Re: SSD-17424905 – 20 Avon Road, Pymble

We refer to Development Application No. SSD-17424905 which proposes the following works:

'Redevelopment of Pymble Ladies College-Grey House Precinct, comprising a five-storey building to accommodate the following:

Figure 3: Extract of Acoustic Report - Proposed acoustic walls

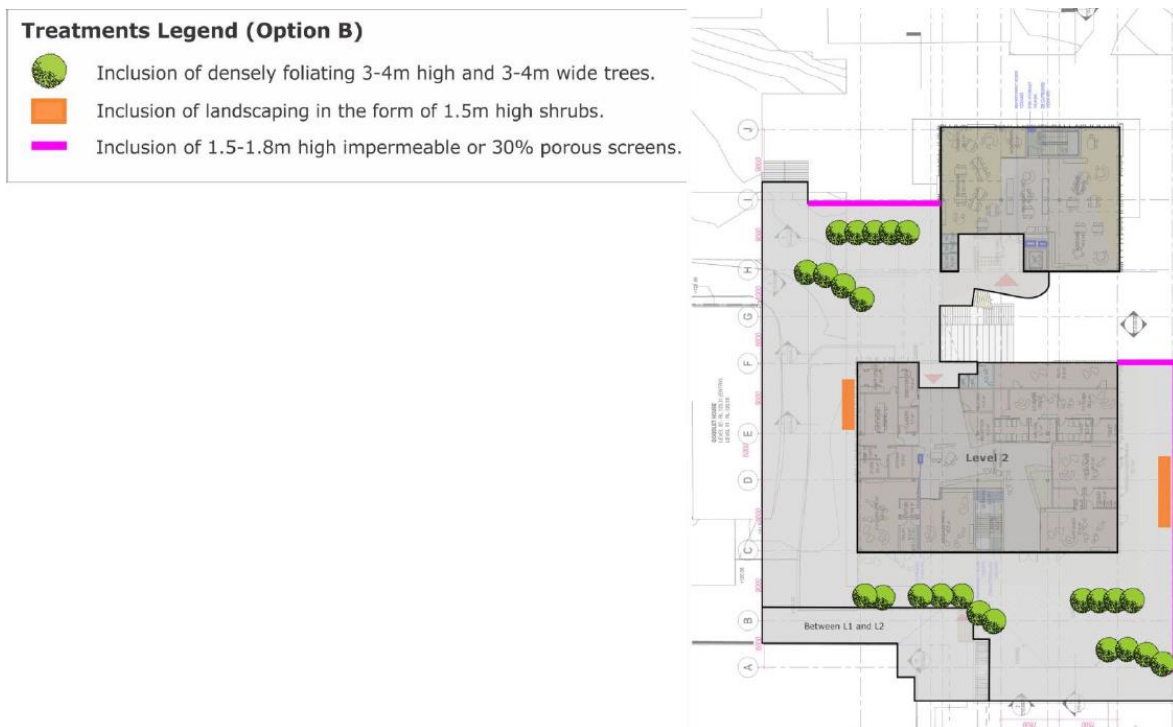
The documentation submitted with the application contains discrepancies between the noise impact assessment (NIA) and architectural plans with regard to an acoustic wall associated with the ELC.

The NIA recommends a solid barrier to the perimeter of the level 2 external play area of the ELC, such as glass or the like with a height of no less than 1.5m above the floor of level 2. However, the architectural plans indicate a metal palisade fence to the perimeter of the level 2 outdoor play area. Further, the wind study recommends a 1.5-1.8m high impermeable or 30% porous screen along the north-eastern and south-eastern boundaries of the level 2 outdoor play area – see extract from NIA below:
